PARTS & SERVICE NEWS

REF NO.	AT04296
DATE	December 9, 2004

SUBJECT: MODIFICATION OF THE AXLE SUPPORT RUBBER BUSHING FIXING

PLATE

Fig. 1
2. Securons applicable to this modification

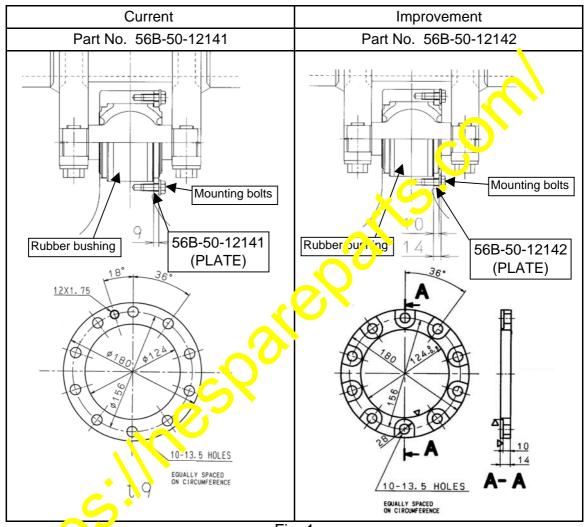
The thickness of the rubber bushing fixing plate has been changed from t9 to t14 to increase the rigidity of the plate. It decreases the stress applied to the bolt and prevents the bolts from being broken. (See Fig. 1)

If the bolts are broken, the rubber bushing will not be fixed in the axial direction and it will become broken.

If the bolts are broken with any of the axles, replace the rubber bushing also at the same time.
